PLANNING REPORT

DUBLIN VILLAGE APARTMENTS 22-163CP

Case	22-163CP, Concept Plan at PID: 273-009045
Proposal	Redevelopment of an existing 229-space surface parking lot and the construction of new six-story corridor building with 301 multi-family units, ±13,200-SF of ground-floor commercial space, and a 453-space parking structure internal to the building on a ±3.85 acre site.
Request	Review and approval of a Concept Plan under the provisions of Code §153.066.
Zoning	BSD-SCN, Bridge Street District – Sawmill Center Neighborhood
Planning Recommendation	Disapproval of the Concept Plan.
Next Steps	Should the Commission approve the Concept Plan, the applicant may proceed to the Preliminary Development Plan application.
Applicants	Aaron Underhill, Underhill and Hodge Matt Stavroff and Kevin McCauley, Stavroff Land Development Michael Fite, F2 Companies
Case Manager	Christopher Will, AICP, Planner (614) 410-4498 cwill@dublin.oh.us

May 2022 Proposal

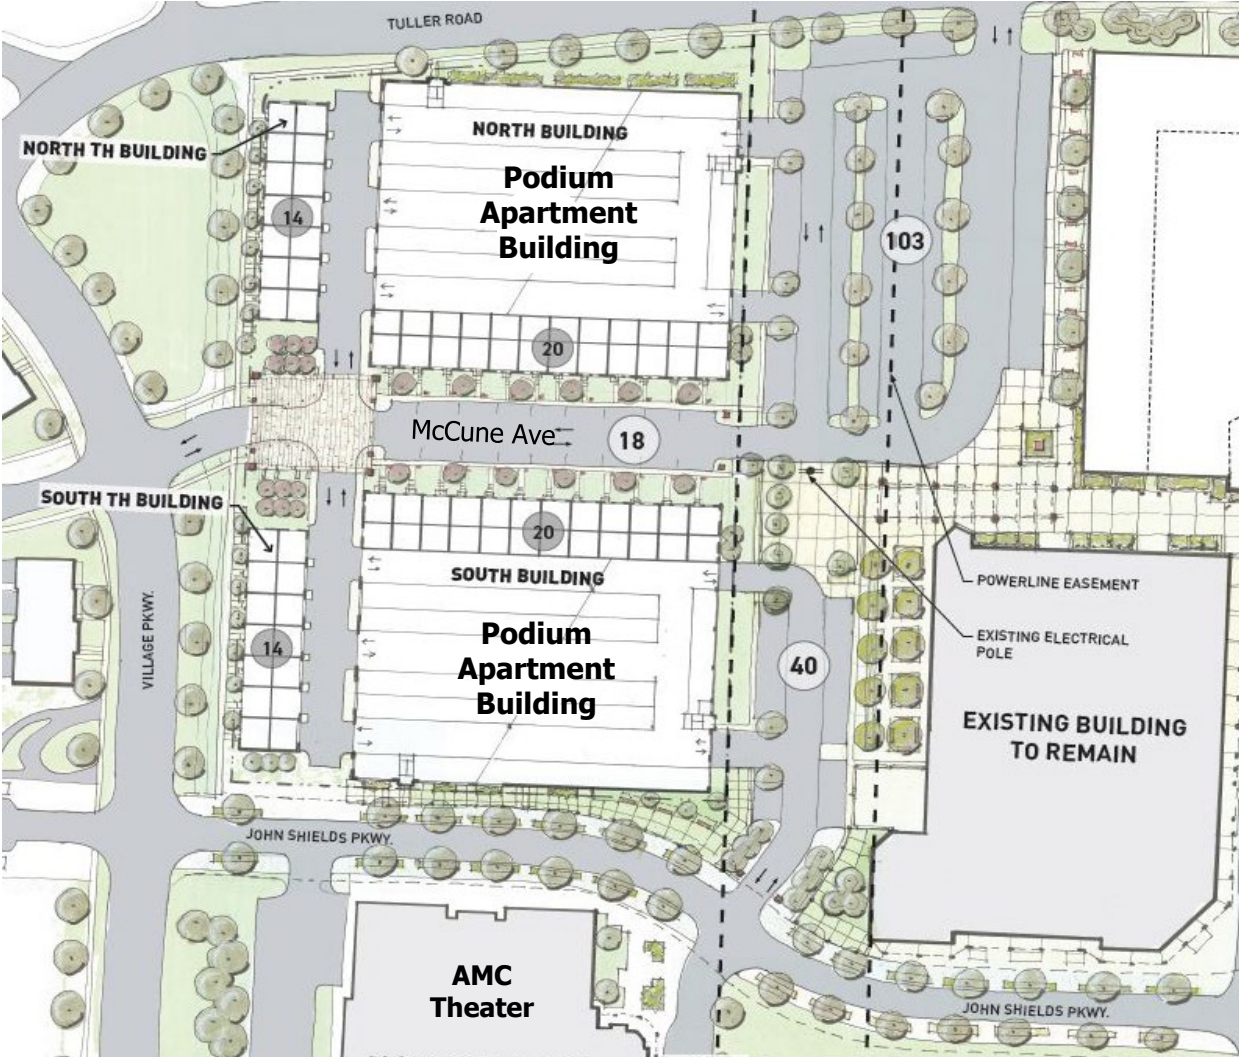
Commission Comments: The Commission was supportive of residential apartments and townhomes as the primary use but encouraged the applicant to further activate the ground-floors especially fronting the Principal Frontage Streets.

Commission Comments: The Commission commended the applicant for recognizing the value of the east-west streets but the development should also solve the north-south street needs as the proposal does not fulfil the Street Network. The Commission supported the creation of the two blocks and emphasized the need to improve the walkability of the proposal.

Commission Comments: The Commission supported structured parking but expressed concern with three sides of each of the podium apartment buildings showing a two-story parking garage, which is not consistent with a pedestrian-oriented district. The Commission expressed concern of the operations for shared parking would look like between the proposed development and the various existing commercial developments in Dublin Village. The Commission expressed support for the applicant to explore parking below ground to preserve above ground stories for active uses.

Commission Comments: The Commission expressed the openness of considering higher building heights but referenced the importance of neighborhood context in evaluating

building heights. The Commission cited evaluating the proposal (6-7 stories) based on heights of existing buildings (3-story and one-story buildings) would not appear to fit within the area fabric, however, provided context to what future development at Dublin Village would look like might provide additional context.

Commission Comments: The Commission noted the intent of the Sawmill Neighborhood District is to be a distinct district unique from the Scioto River Neighborhood District and Bridge Park and that the scale of buildings are an important factor in creating that distinctness. The Commission encouraged the applicant to consider how the edges of the proposed development would transition to the surrounding development.

Commission Comments: The Commission was resolute that open space requirements, including quantity and quality were met and that open space be connected with the BSD's system of open space and integrated within the City fabric. The Commission also expressed the view that the absence of open space depicted demonstrates that the site is presently over-built. The Commission stated they might be supportive of centralizing the open space within the greater Dublin Village development if a framework plan was provided. The Commission was not supportive of a fee-in-lieu for open space.

Update(s) by Applicant: Following the Commission's feedback, the applicant updated the proposed development to include commercial tenant space at the ground-floor fronting the proposed John Shields Parkway. The applicant is still proposing residential as the primary use but has removed the separate townhomes and is now only proposing apartments.

Update(s) by Applicant: The applicant continues to proposing the extension of John Shields Parkway and has updated the proposed to include a new north-south street, however, the east-west extension of McCune Avenue is no longer proposed. Previously the proposed extension of McCune Avenue created two blocks, the applicant is now proposing a single combined block. Sidewalks were previously proposed along the McCune Avenue extension, with the elimination of the street extension in the updated proposal the only public walks are located along Tuller Road and the proposed extension of John Shields Parkway.

Update(s) by Applicant: The applicant is proposing a single larger parking structure when two were previously proposed. One level of parking remains proposed above grade and one partially below grade. While previously the parking layers of the proposed garage were exposed on three of four sides the applicant has added residential and commercial space so that parking is only exposed on one side of the building to address the Commission's comments.

Update(s) by Applicant: The applicant previously proposed two, 6/7-story podium buildings (podium buildings are permitted to be 3 to 4.5 stories) and two, 3-story townhouse style single-family attached buildings (single-family attached buildings are permitted to be 1.5 to 4 stories). The applicant is now proposing a single, 5/6-story apartment corridor building.

Plan Update(s): Previously, the applicant proposed four buildings - two, 6/7-story and two, 3-story townhouse style buildings with the 3-story buildings across the street from presently under-construction the 3-story Towns on the Parkway (TP). The proposed 3-story buildings were between the TP townhomes and the taller 6/7-story buildings to the east. The updated proposal illustrates one, continuous 5/6-story building. The 6-story elevation of the building is on the same block-face as the 3-story TP townhomes.

Update(s) by Applicant: A large open space centralized to the Dublin Village development has been removed. The existing plaza in front of the AMC Theater and a new open space west of Revelry Taverns is now proposed to be included in this development. The applicant continues to propose similar open spaces around the periphery of the building.

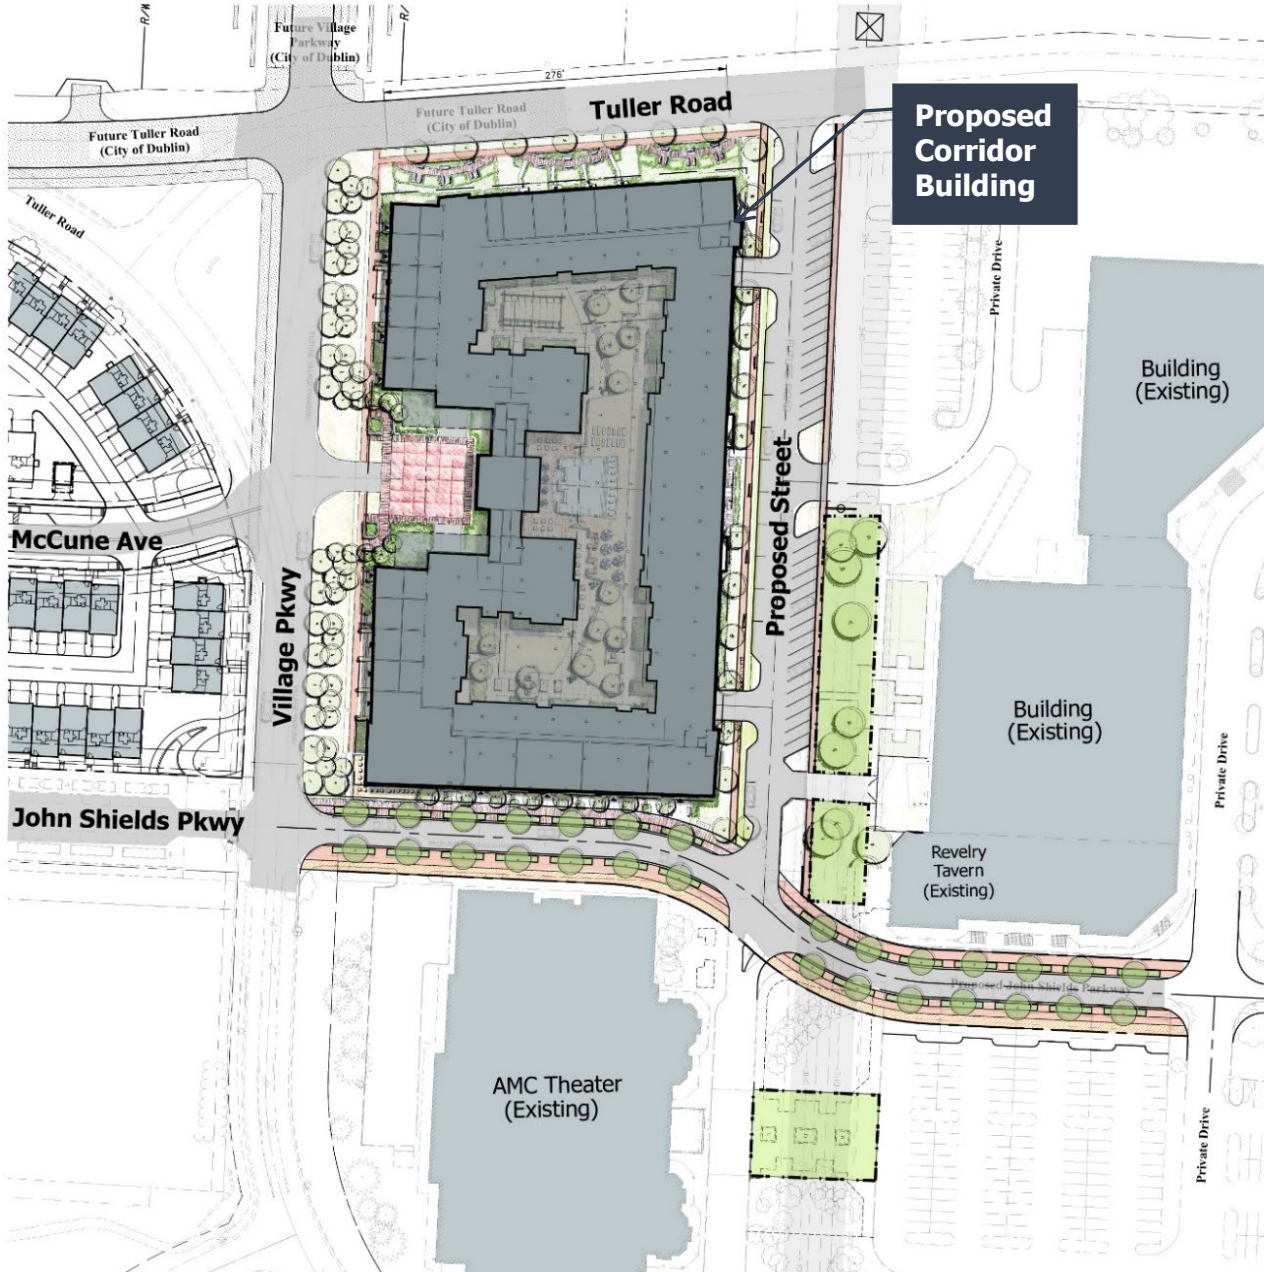
Commission Comments: The Commission expressed that seeing a framework plan for the larger plan for Dublin Village could provide context for the applicant's long-term vision and for the evaluation of the proposal and that an eclectic redevelopment would be good but there must be a framework plan to provide guidance, specifically for streets, open space, and building scale.

Update(s) by Applicant: The applicant provided a framework plan which illustrates potential future redevelopment of Dublin Village, including streets, buildings, and open space. This is for reference purposes only. The Commission is not asked to review or approve this framework plan as it is not part of this proposal. The reference framework plan would require a separate Concept Plan application for review.
